LANDING GEAR - LANDING GEAR WARNING HORN REPLACEMENT

The original landing gear warning horn is no longer available. If the landing gear warning horn needs to be replaced, a new landing gear warning horn is available and will require an additional bracket for installation.

MEB-32-02  
Page 1 of 25

Figure 10. 335/340A Configuration 3 (Sheet 1)

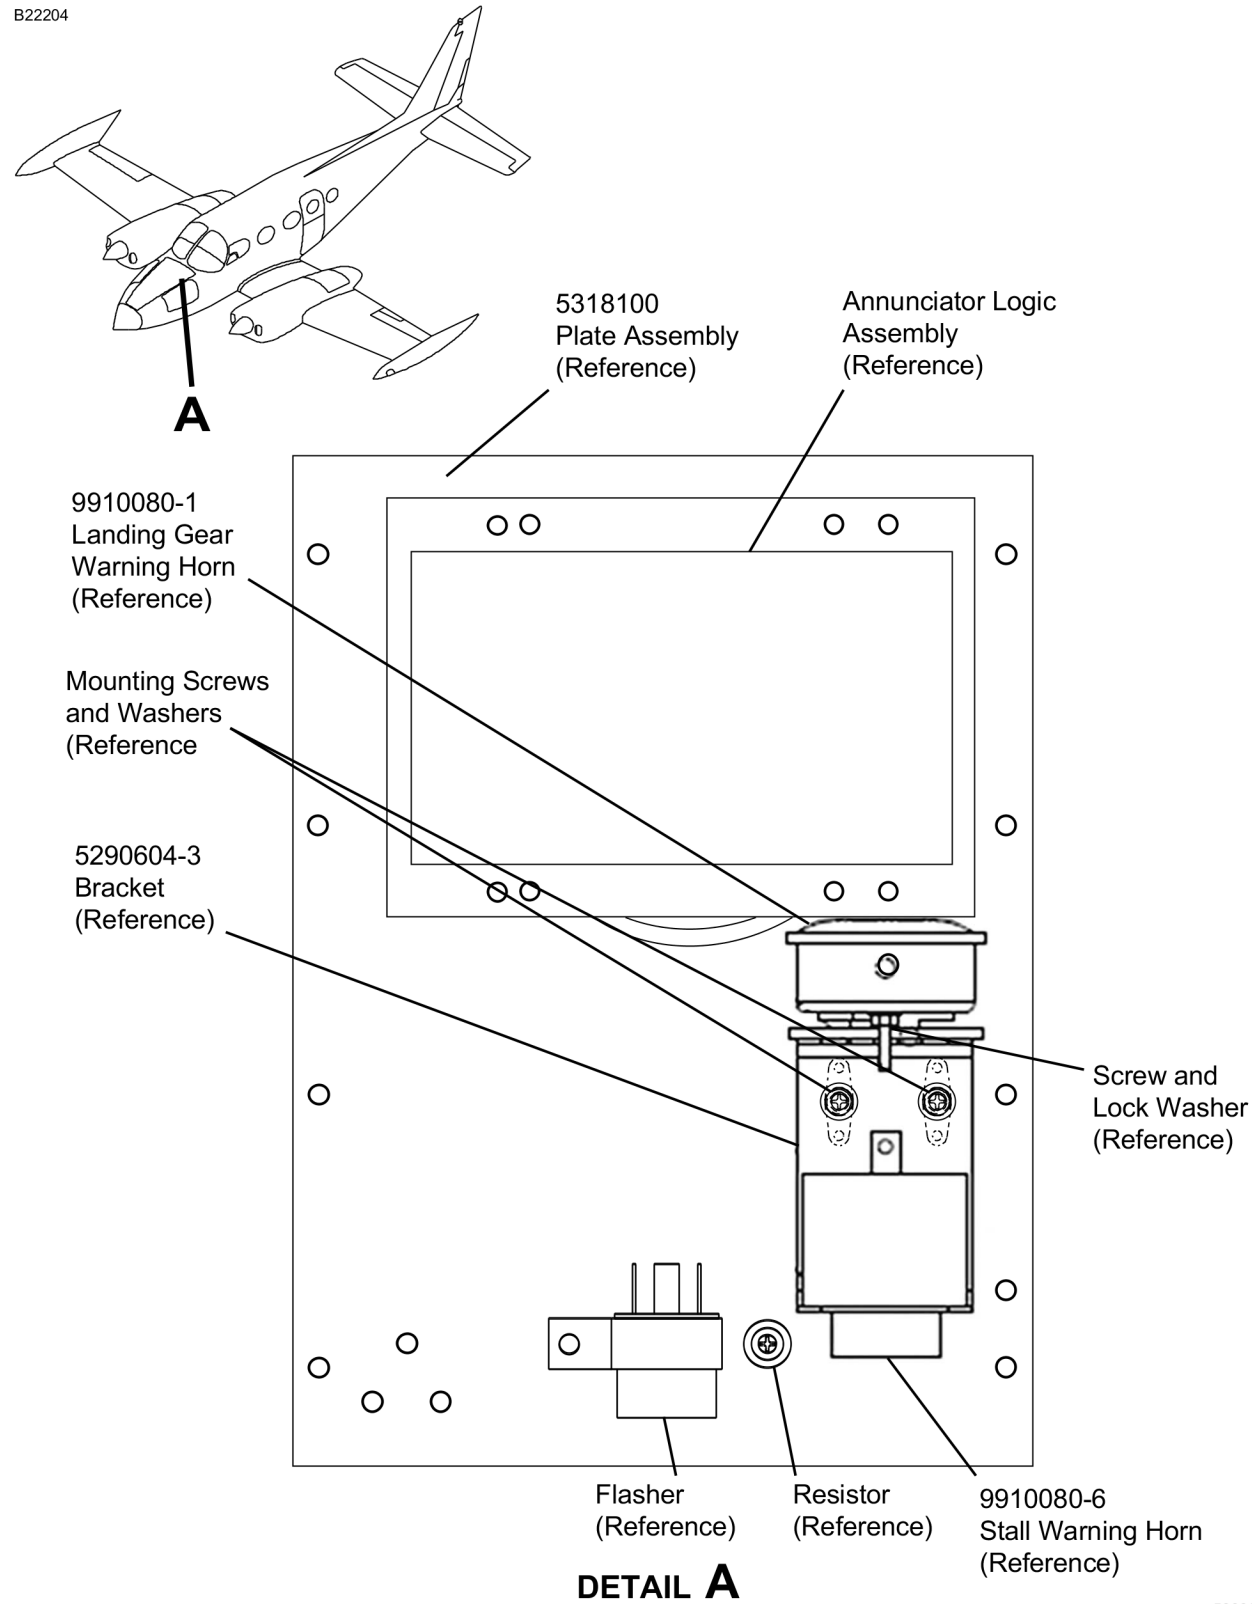
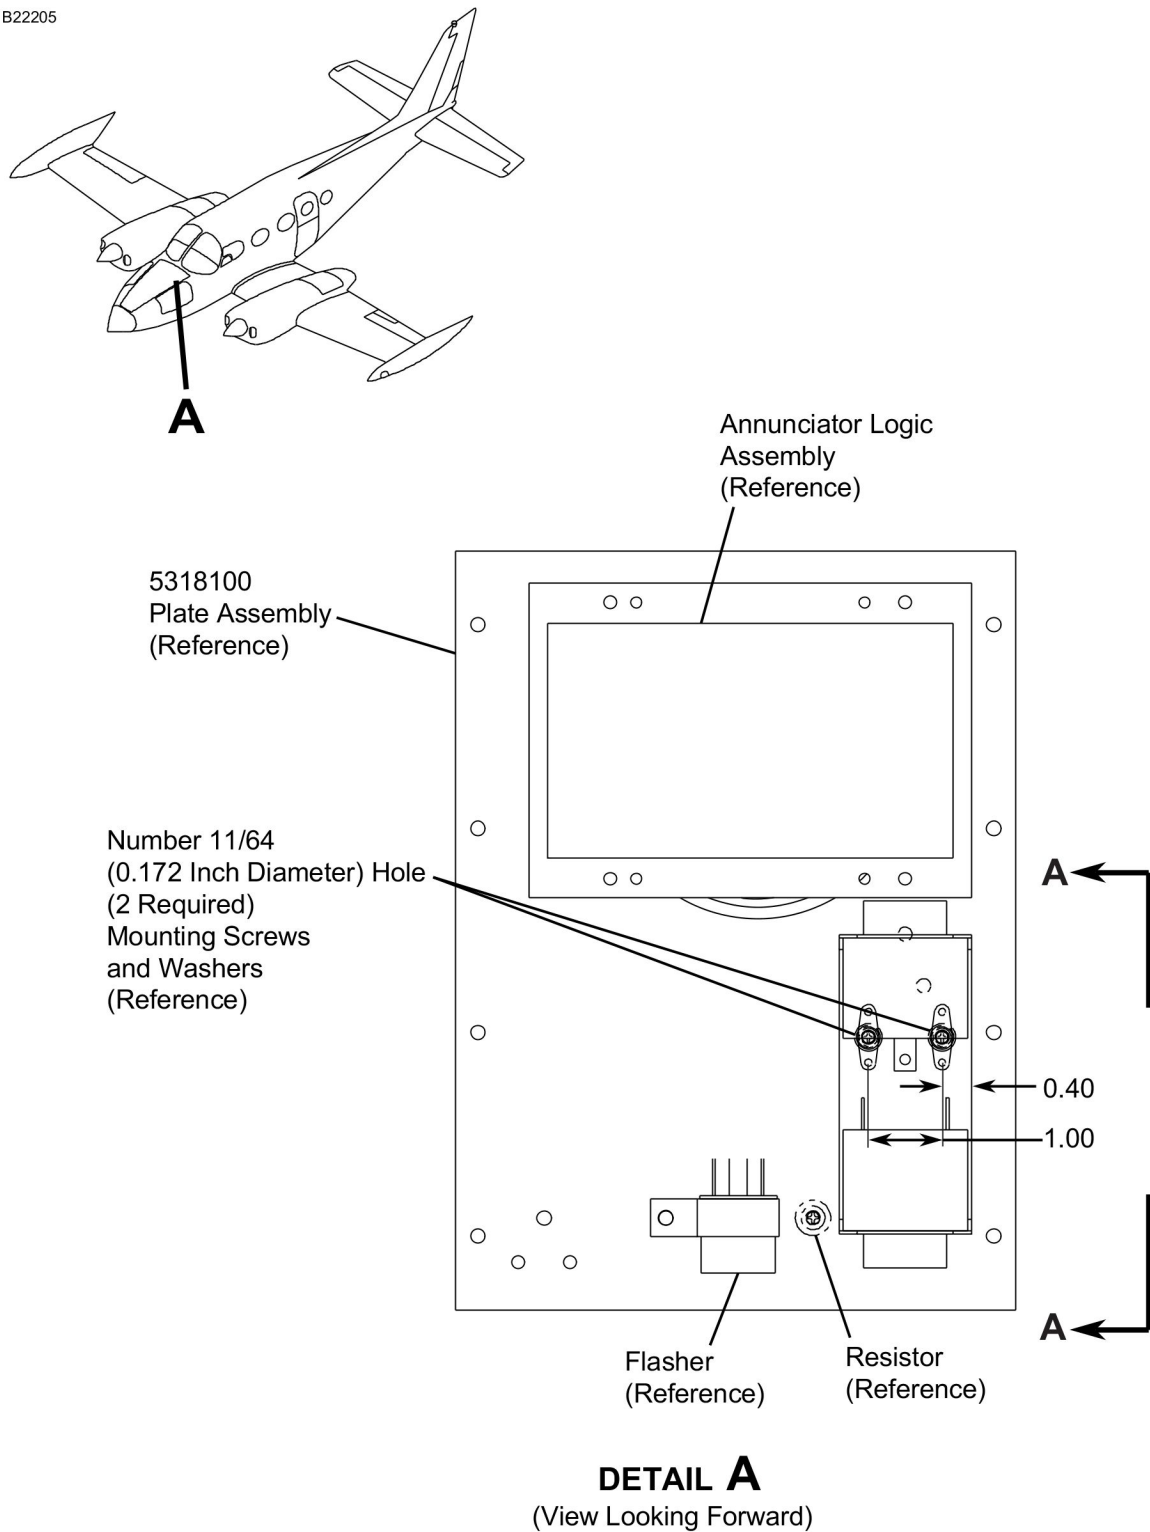
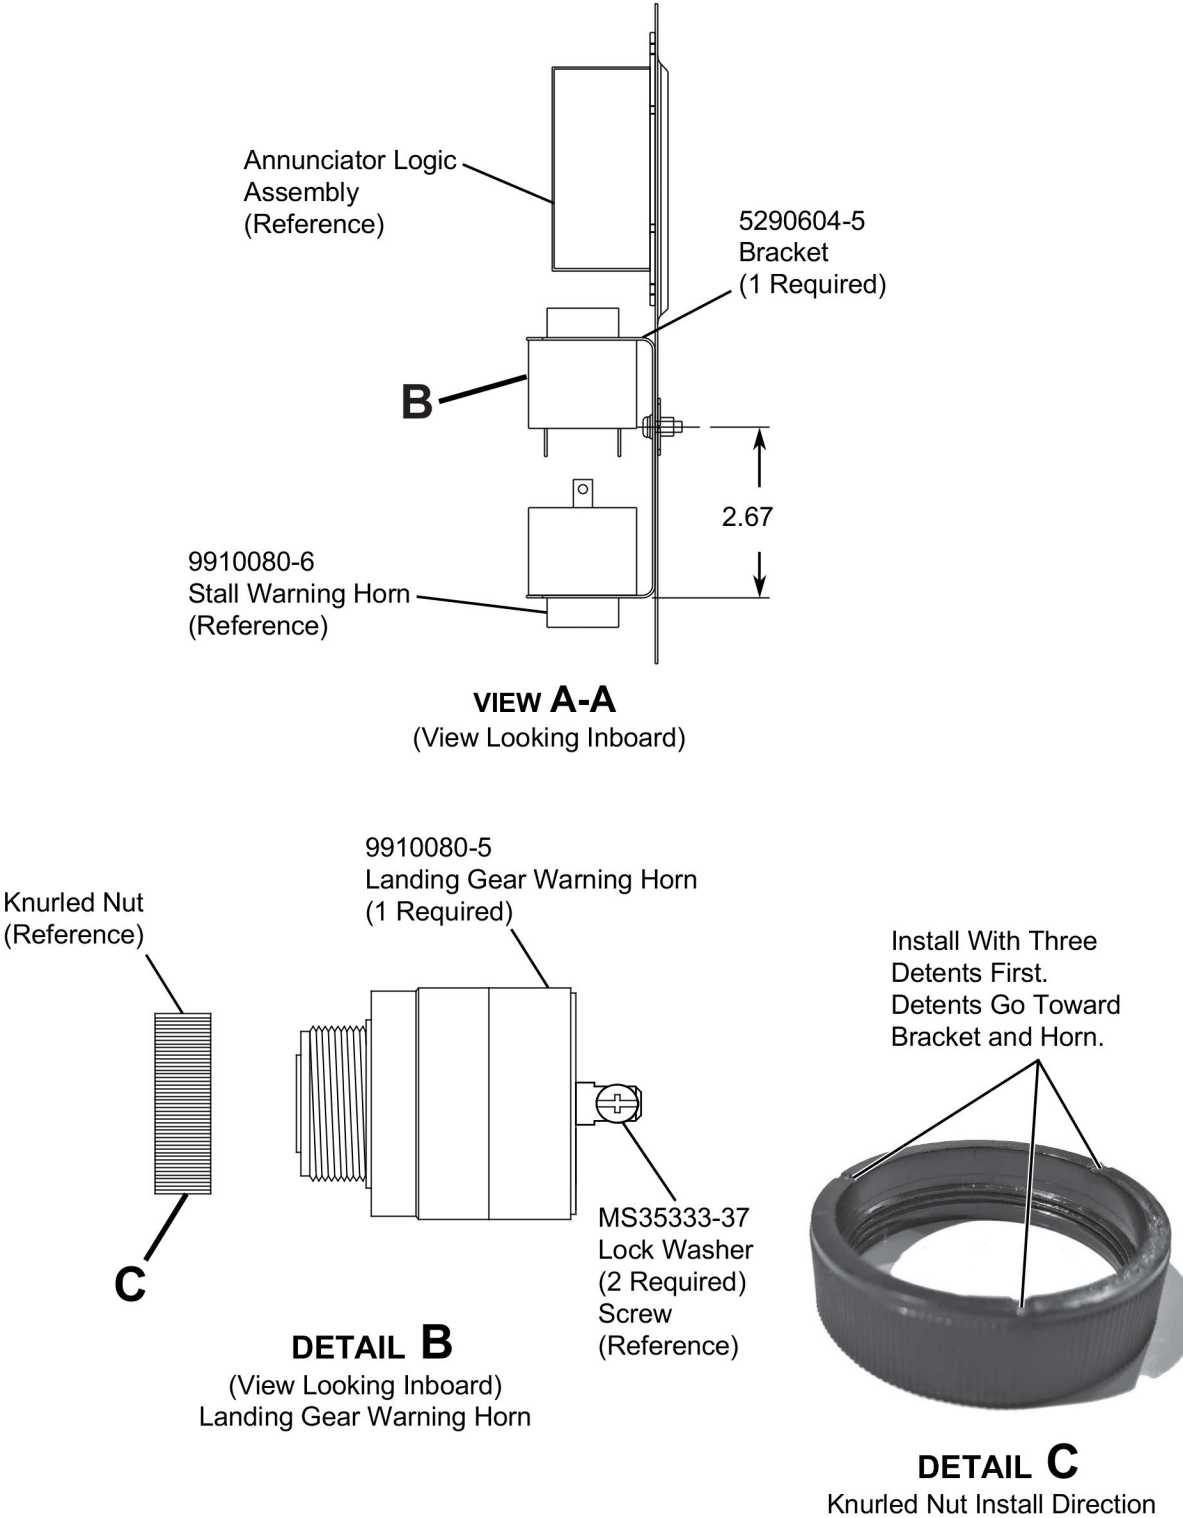
14. (For Model 340 Refer to Figure 7, Sheet 1, and for Model 335/340A Figure 9, Sheet 1.) Remove the 9910080-1 Landing Gear Warning Horn as follows:
- A. Remove and discard the washer and lock screw from the 9910080-1 Landing Gear Warning Horn.
  - B. Disconnect and label the electrical wiring from the 9910080-1 Landing Gear Warning Horn.
  - C. Discard all electrical hardware from the 9910080-1 Landing Gear Warning Horn.
  - D. Discard the 9910080-1 Landing Gear Warning Horn.
  - E. Remove and keep the 9910080-6 Stall Warning Horn.

15. (For Model 340 Refer to Figure 8, Sheet 1 and 2, and for Model 335/340A Figure 10, Sheet 1 and 2.) Install the 9910080-5 Landing Gear Warning Horn as follows:

- B. (For Model 335/340A airplanes.) Match drill the two Number 11/64 (0.172 inch diameter) holes of the 0818109 Support Assembly to the 5290604-5 Bracket.

- (1) Debur the drilled holes from the 5290604-5 Bracket.
  - (2) Apply Color Chemical Film Treatment to all bare metal.
  - (3) Install the 5290604-5 Bracket with the two kept mounting screws and the two kept washers into the 5318100 Plate Assembly.

- C. Install the 9910080-5 Landing Gear Warning Horn into the 5290604-5 Bracket.
